The Arcade and 18-20 Corporation Street and 17 Foundry Street, Dewsbury

Summary of Amendments

Doc No. 1705-BDP-AD-XX-RG-Z-00005
Revision: P01
Date: 18 June 2026

1 Roof Plan_Proposed
1 : 100

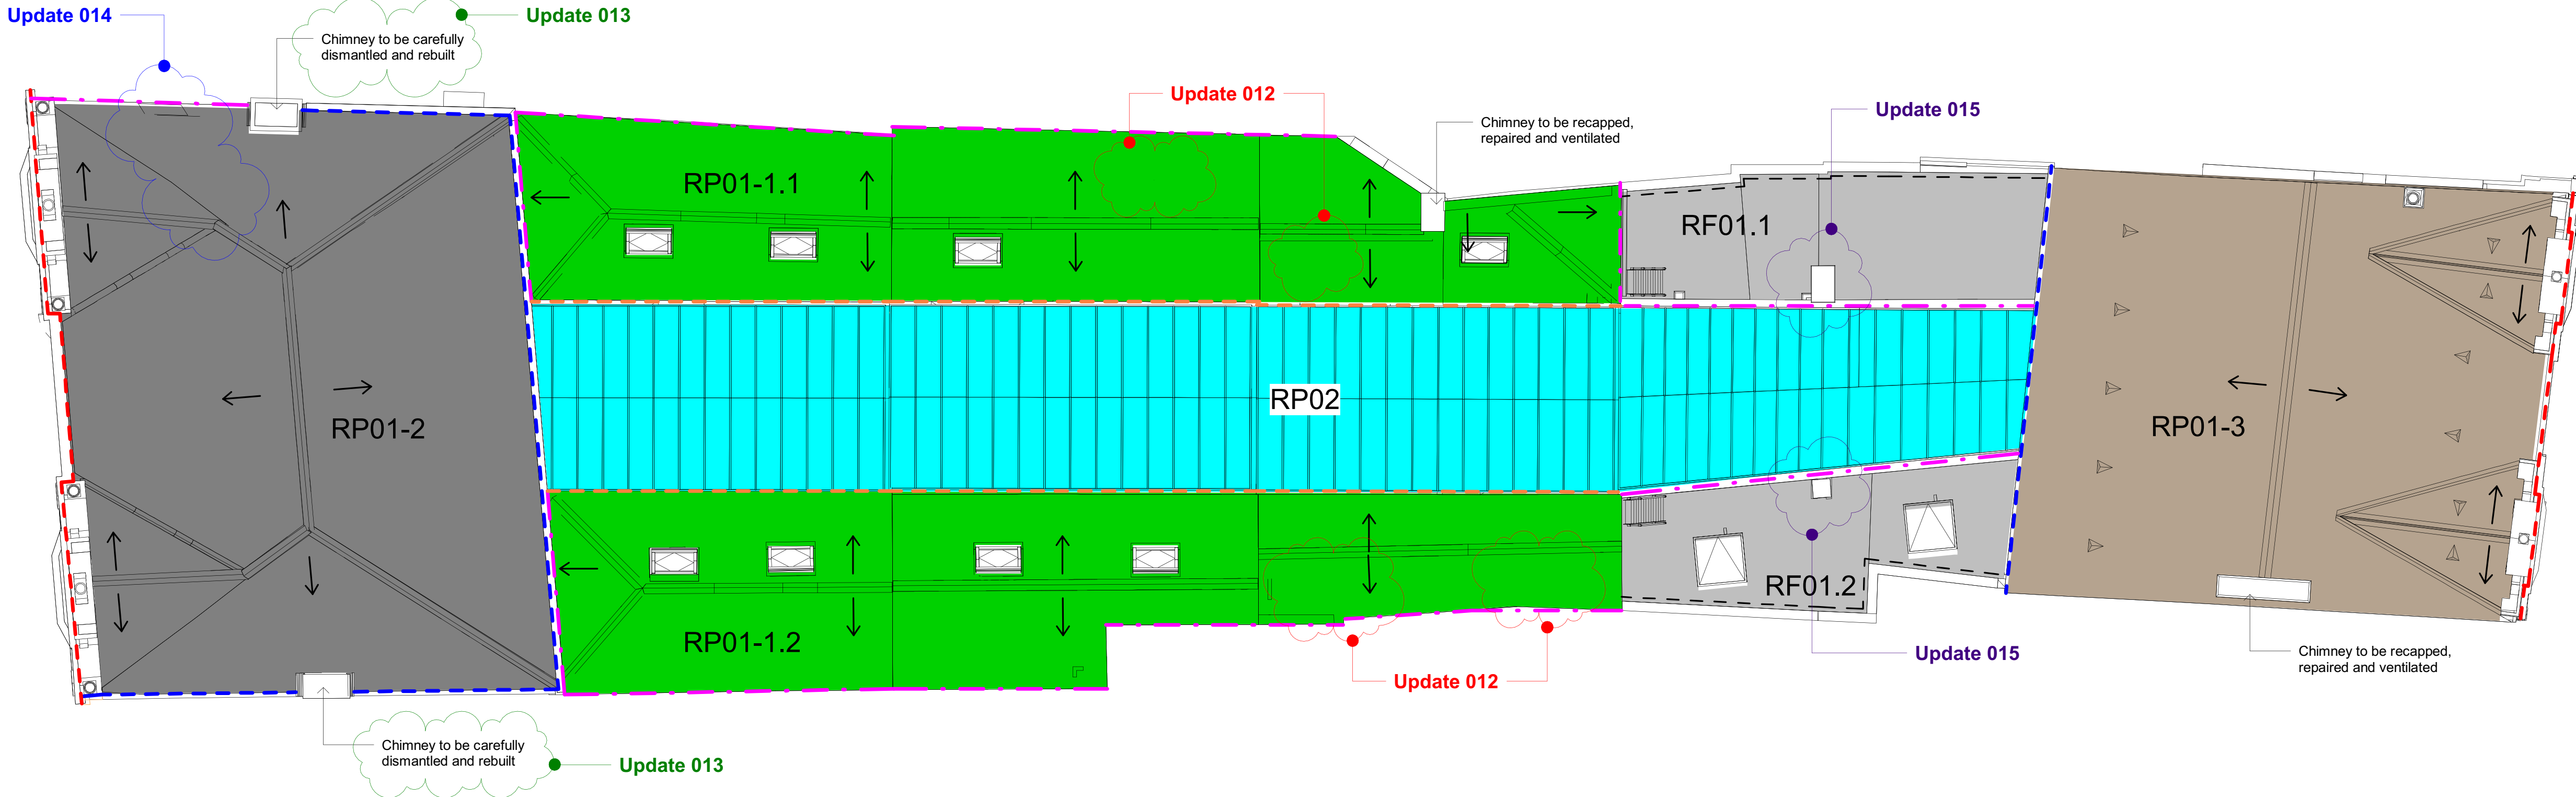
010	23-25 Market Place Unit 29	Door opening	Create a new door opening in unit 29 to allow a space to be separated into a corridor and a room.	n/a	Opportunity to omit the new door opening and reuse the existing opening for both the corridor and the adjacent room.	Reconfigure the proposed corridor and omit the new opening in this existing wall	1705-BDP-AD-02-PL-A-20001_T01	1705-BDP-AD-02-PL-A-20001_T02
011	14-16 Corporation Street Unit 30	Floor hatch	Retain existing floor hatch.	The floor hatch and the trimming around it was found to be structurally unsafe.	The structural engineer confirmed the existing structure was unsuitable for the proposed building use.	Remove the access hatch and trimming, and infill the area with concrete to tie into the existing concrete (filler joist) floor structure in this area.	1705-BDP-AD-02-PL-A-20002_T01	1705-BDP-AD-02-PL-A-20002_T02
012	Central Arcade First floor units	Rooflights	Remove existing rooflights and install a new secure rooflight to each first floor unit in the central arcade area.	The spacing between the existing purlins varies.	The purlin spacing in 4no. of the units is too close to allow a modern secure rooflight to be installed.	Omit 4no. rooflights to units 7a, 9, 18e and 18f. The remaining 6no. rooflights to the other units in this area will still be installed.	1705-BDP-AD-RF-PL-A-20005_P01	1705-BDP-AD-RF-PL-A-27001_P02

013	14-16 Corporation Street	Chimneys	The two chimneys were intended to be repointed and recapped.	Following a fingertip survey of the existing, these chimneys were found to be in a poor condition, with suspected sulphate attack to the masonry, causing leaning.	Leaving the chimneys in this condition would pose a safety risk. They would potentially also be a weak point for further moisture to enter the building, and are not easily accessible for ongoing repairs.	Carefully dismantle and rebuild the chimneys straight and plumb, reusing the existing stone wherever possible and supplementing with new to match.	1705-BDP-AD-RF-PL-A-20005_P01 1705-BDP-AD-XX-EL-A-20001_P01 1705-BDP-AD-XX-SE-A-20001_P01	1705-BDP-AD-RF-PL-A-27001_P02 1705-BDP-AD-XX-EL-A-20001_T02 1705-BDP-AD-XX-SE-A-20001_T02
014	14-16 Corporation Street	Rooftop walkway	A covered rooftop walkway had been added to connect this roof storage deck to the third floor of 18-20 Corporation Street. This was shown as remaining in location.	This walkway was found to be built using modern materials and was in a poor condition.	Opportunity to remove an inappropriate modern addition and return the profile of the roof to its original state. This is also on the principal elevation of the building, facing onto Corporation Street.	Carefully remove the modern walkway and continue the form of the original slate roof covering over this area of the roof.	1705-BDP-AD-RF-PL-A-20005_P01	1705-BDP-AD-RF-PL-A-27001_P02

023	17 Foundry Street	Stairwell	A store was included at the end of the second floor space at the head of the stairwell.	n/a	For building regulations and fire evacuation, it has been proposed that the store room should be omitted.	Omit this store room.	1705-BDP-18-ZZ-PL-A-00002_P06	1705-BDP-18-ZZ-PL-A-00002_P07
024	18-20 Corporation Street Units 35 and 36	Floor coverings	Retain existing floor coverings	These floor coverings were found to be Asbestos-Containing Materials (ACMs).	ACMs pose a health risk to the proposed works when they could be disturbed during the refurbishment, and as an ongoing residual risk when they could be disturbed unknowingly for example by future tenants.	Remove these floor coverings to exposed floorboards.	1705-BDP-18-ZZ-PL-A-00002_P06	1705-BDP-18-ZZ-PL-A-00002_P07
025	Central Arcade	Glazed roof structure	Timber ridge beams, wall plates and principal rafters to be redecorated.	Extensive wet rot to end bearings of ridge beams and principal rafters. Wet rot to exposed faces of wall plates.	The timber surveyor and structural engineer confirmed the existing timber structure was unsuitable for the proposed roof loading.	Replace the timber with new where decayed, using the same profiles, and decorated to match the existing.	1705-BDP-AD-RF-PL-A-20005_P01	1705-BDP-AD-RF-PL-A-27001_P02

DRAWING TITLE
East Elevation

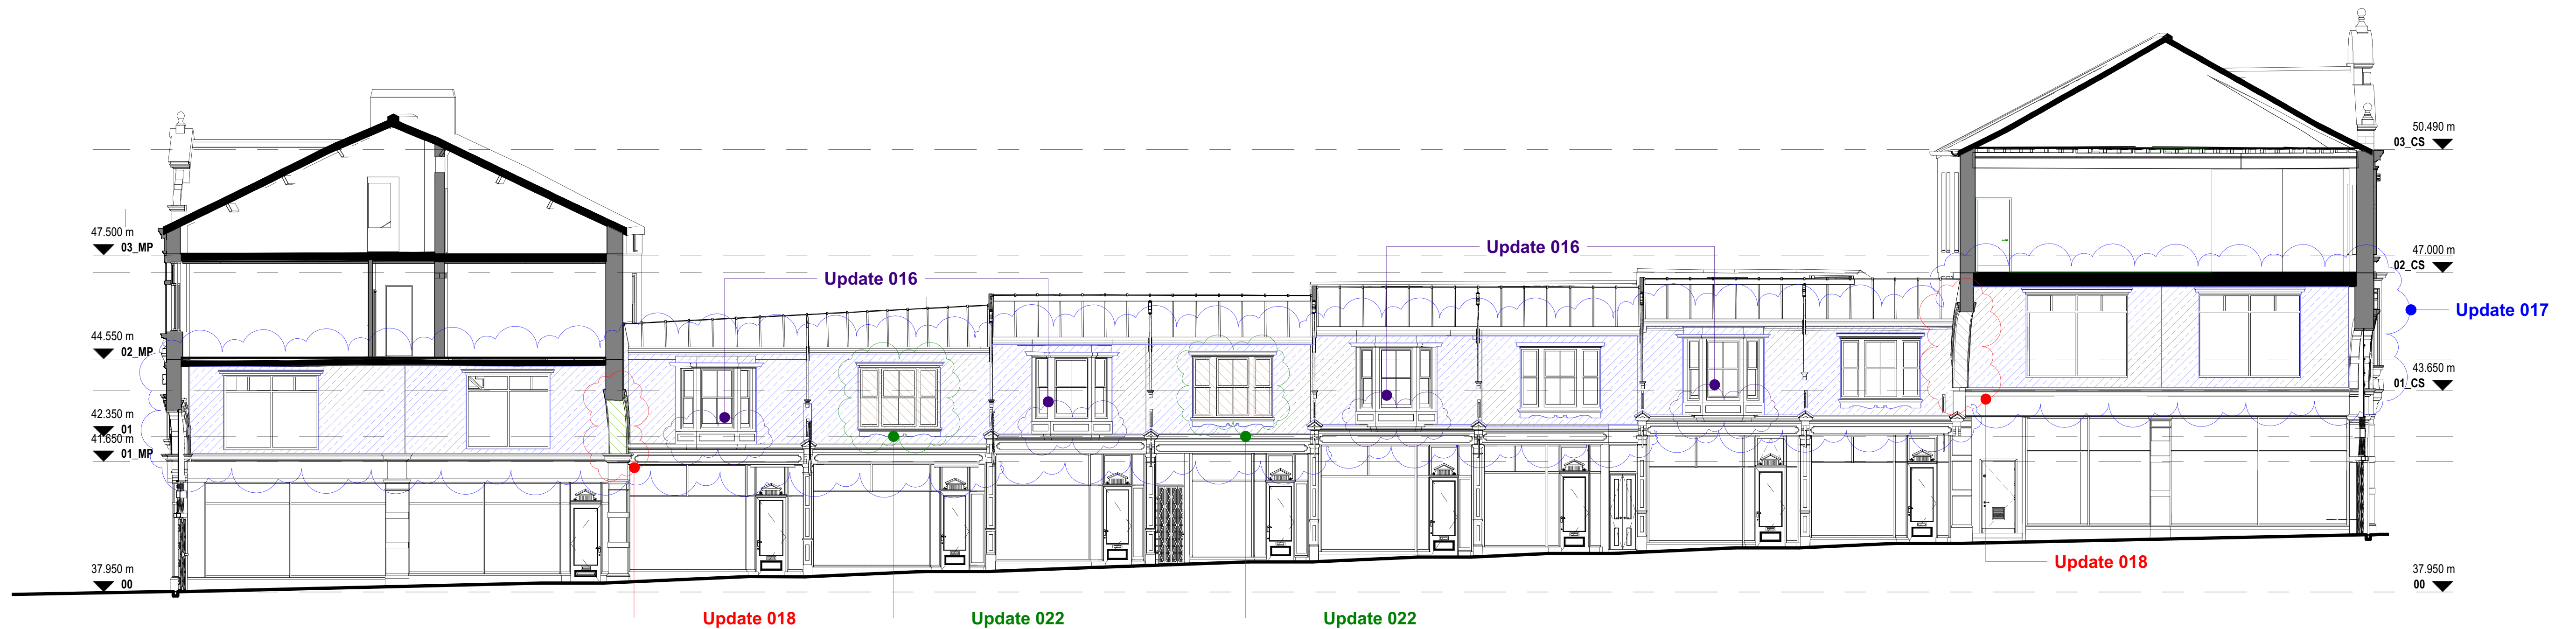
015	Central Arcade Units 3-6	Brick piers over these units	These brick piers were previously assumed to be chimneys which were to be ventilated and recapped.	On close inspection, these have been found to be piers reinforcing the external brick walls at first floor level	n/a	No ventilation or recapping is required.	1705-BDP-AD-RF-PL-A-20005_P01	1705-BDP-AD-RF-PL-A-27001_P02
016	Central Arcade	Internal windows at first floor level	Leave splayed window boxes in position and redecorate	When reviewed on site, it was found that behind the modern splayed window boxes which had been used for fake planting, the original timber panelling still exists.	Removing these modern splayed window boxes would reveal the design and craftsmanship of these original sash windows and their panelling, and return them to their original appearance.	Remove the modern splayed window boxes. Redecorate the original panelling to the same specification as is already proposed for the sash windows.	1705-BDP-AD-XX-EL-A-20005_T01 1705-BDP-AD-XX-EL-A-20004_P01	1705-BDP-AD-XX-EL-A-20003_T02 1705-BDP-AD-XX-EL-A-20004_T02

017	Central Arcade	Render to walls at first floor level	Patch repair the existing render. The render was assumed to be lime-based and repairable.	On inspection, the existing render is modern and cement-based. It also exhibits problems with build-up of moisture.	Cement-based render is non-breathable and inflexible. It is not appropriate for historic buildings and risks damage to the masonry substrate behind.	Carefully remove the existing render and replace with traditional lime-based render which will allow the historic masonry wall to breathe.	1705-BDP-AD-XX-EL-A-20005_T01 1705-BDP-AD-XX-EL-A-20004_P01	1705-BDP-AD-XX-EL-A-20003_T02 1705-BDP-AD-XX-EL-A-20004_T02
018	Central Arcade	Plaster arches beneath each end of the glazed roof	Redecorate plaster arches. The arches were assumed to be in sound condition.	The arches are cracked and there is delamination of the top coats from the bonding coats.	It would not be practical to redecorate the arches in their current condition, and there is currently a risk that parts of the arches could fall onto the public route below if left in this state.	Take profiles of the existing mouldings and replace with new, matching the original materials and profiles, and using traditional techniques.	1705-BDP-AD-XX-EL-A-20005_T01 1705-BDP-AD-XX-EL-A-20004_P01	1705-BDP-AD-XX-EL-A-20003_T02 1705-BDP-AD-XX-EL-A-20004_T02

Section BB

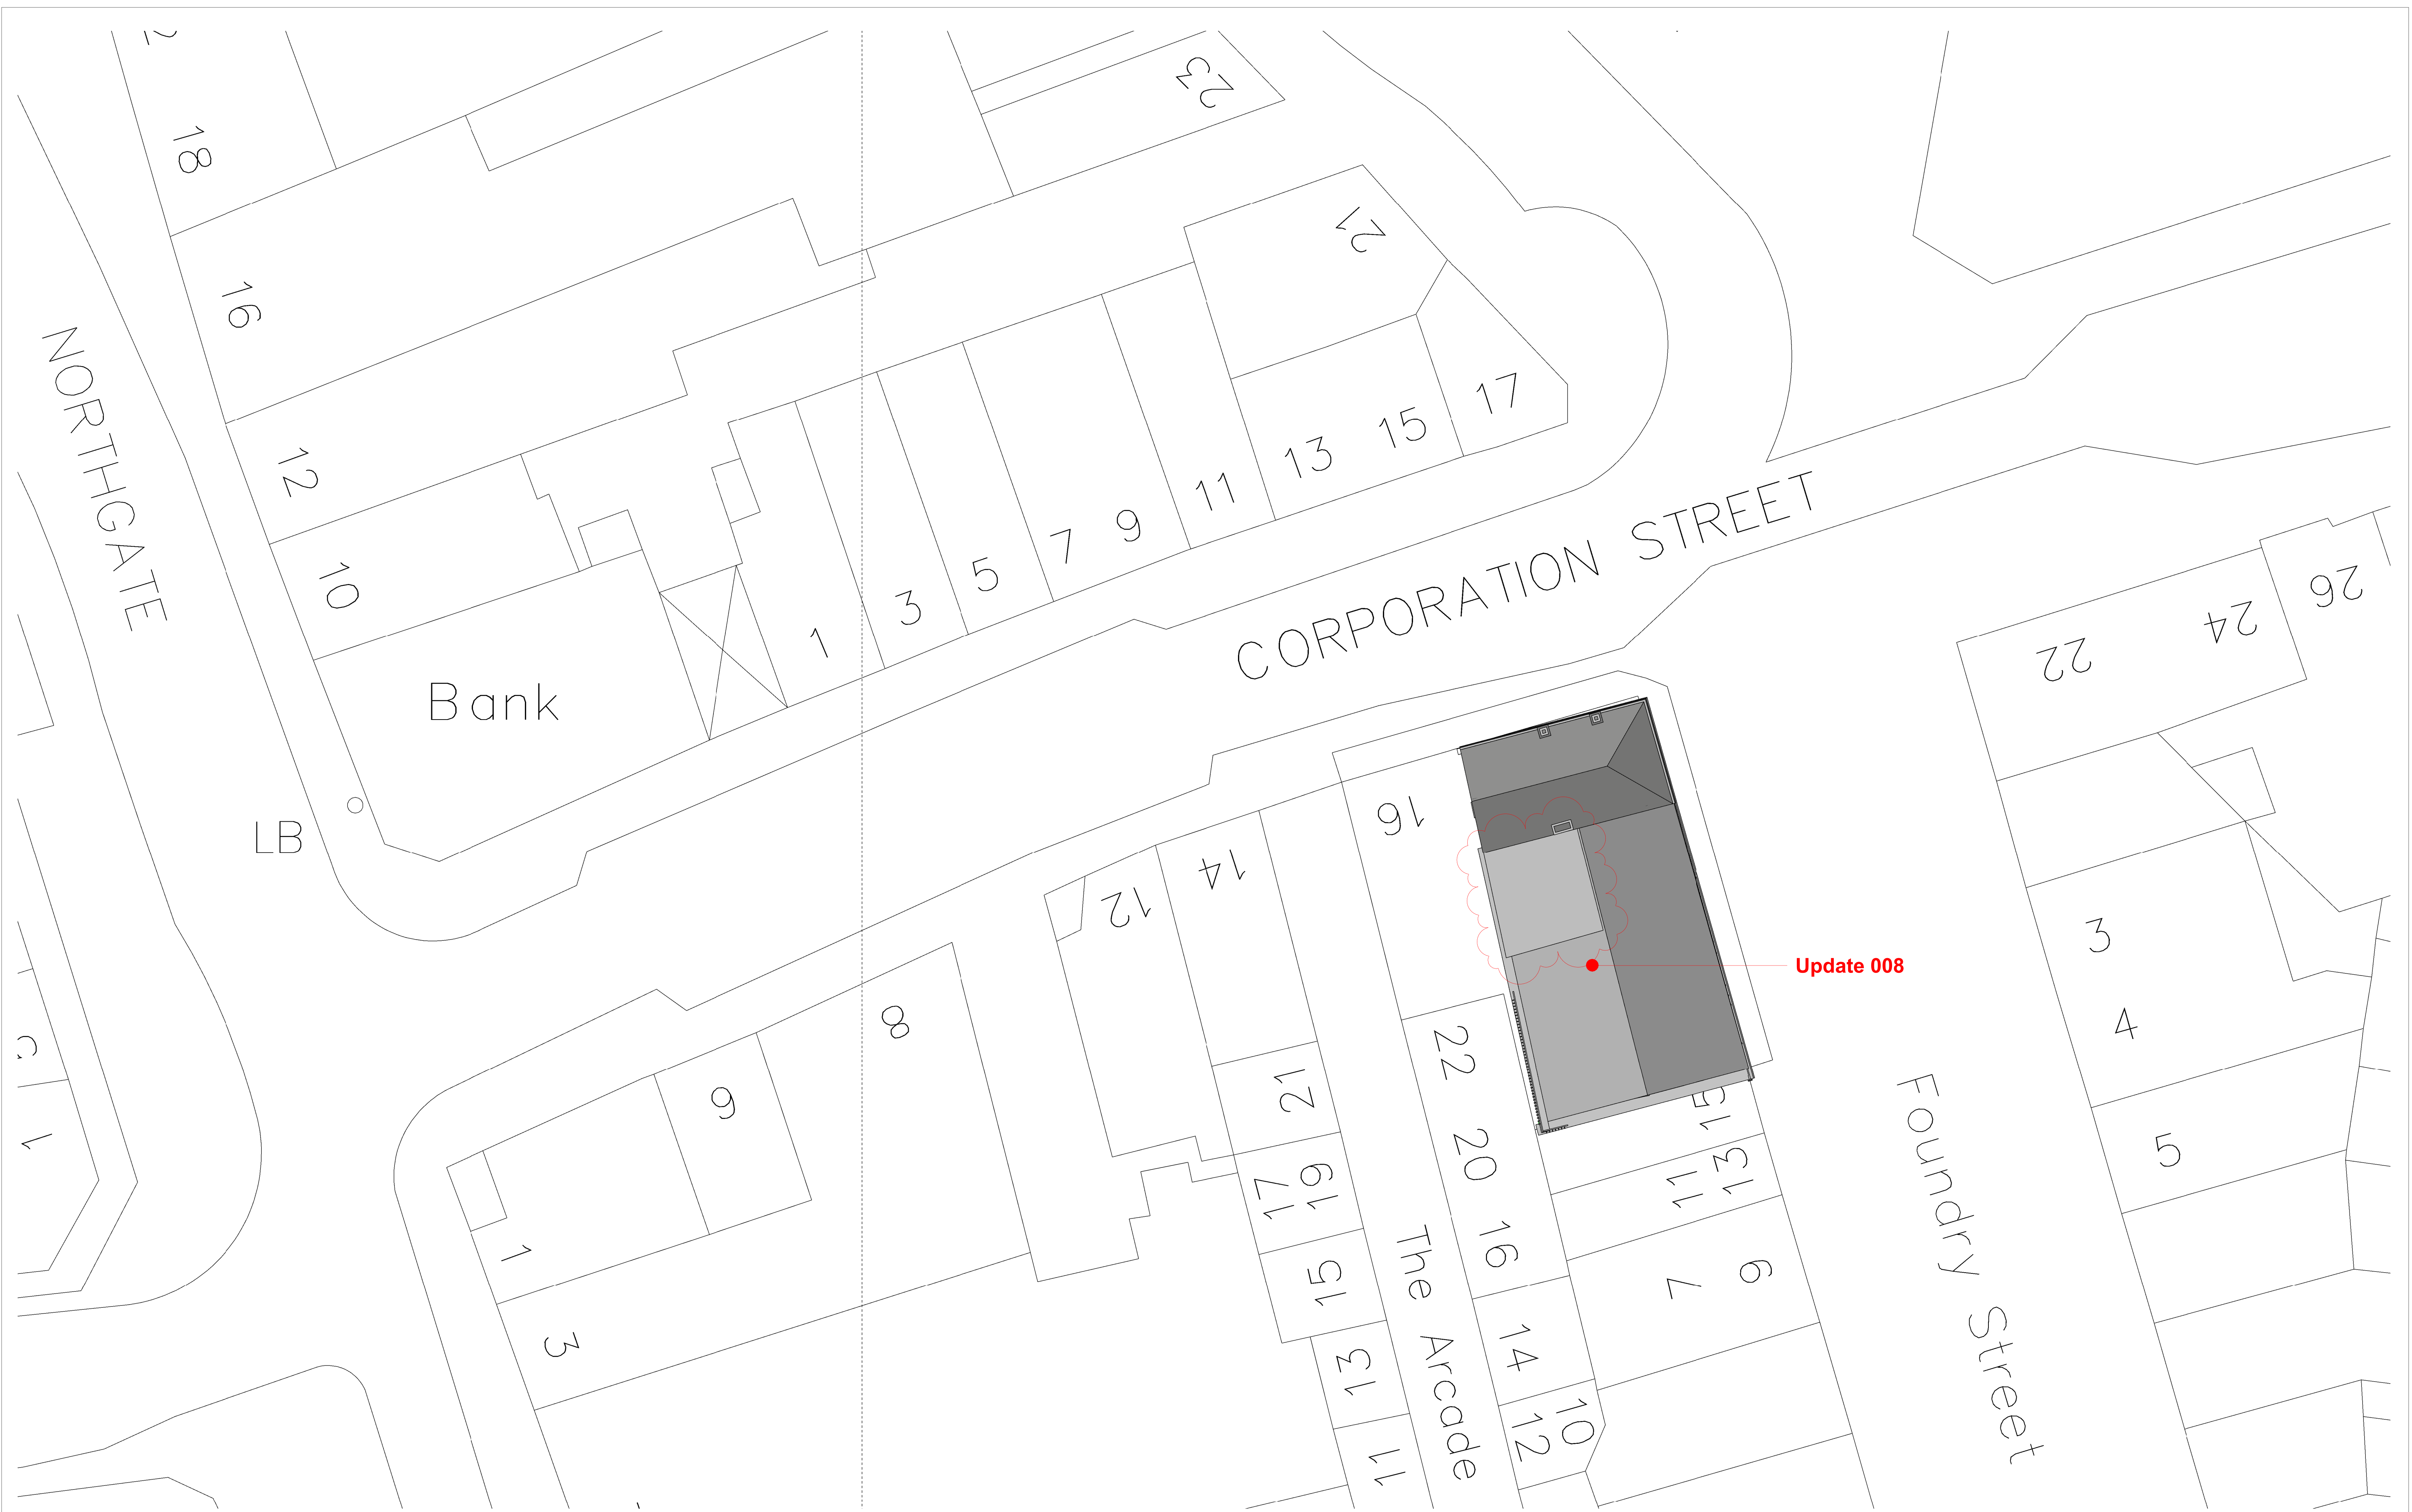
021	23-25 Market Place Rear elevation of Market Place building	Gutter and rainwater pipe	Replace the existing cast iron gutter and rainwater pipe in the same size, profile and material.	Rainwater falling on the rear pitch of the Market Place roof falls into valley gutters and the eaves gutter, then into a single rainwater pipe which discharges into the glazed roof gutter, which transports rainwater back towards Corporation Street, into another rainwater pipe, onto the top of a slate roof, into another gutter, into an outlet, and then into an internal rainwater pipe.	This route is extremely convoluted, and has multiple junctions. There is evidence of past leaks in some areas below. A single rainwater pipe for this large area of roof provides no secondary resilience. It also seems unlikely that this was the original route for rainwater discharge.	Remove the existing single rainwater pipe, provide new cast iron rainwater pipes (to match existing profile) at both ends of this gutter discharging directly to the flat roof drainage.	1705-BDP-AD-XX-SE-A-20002_P01	1705-BDP-AD-XX-SE-A-20002_T02

022	Central Arcade, 14-16 Corporation Street and 18-20 Corporation Street Refer to elevation drawings	Windows	Repair windows where possible using traditional techniques. Some windows were known to have extensive wet or dry rot, or were absent and were therefore proposed to be replaced.	Additional windows were found to have extensive wet and dry rot. (2 to 14-16 Corporation Street North Elevation, 2 to Central Arcade East Elevation, and 2 to Central Arcade West Elevation, 3 to 18-20 Corporation Street North Elevation)	These additional windows are so extensively decayed that they are unsuitable for repair.	Replace 6 no. windows, in addition to the 3 no. already proposed to be replaced (in unit 30, shown on Section AA). Replacement windows to match existing in size, proportions and timber profiles.	1705-BDP-AD-XX-EL-A-20001_P01 1705-BDP-AD-XX-EL-A-20005_T01 1705-BDP-AD-XX-EL-A-20004_P01 1705-BDP-AD-XX-SE-A-20002_P01 1705-BDP-18-ZZ-EL-A-00002_P04	1705-BDP-AD-XX-EL-A-20001_T02 1705-BDP-AD-XX-EL-A-20003_T02 1705-BDP-AD-XX-EL-A-20004_T02 1705-BDP-AD-XX-SE-A-20002_T02 1705-BDP-18-ZZ-EL-A-00002_P05
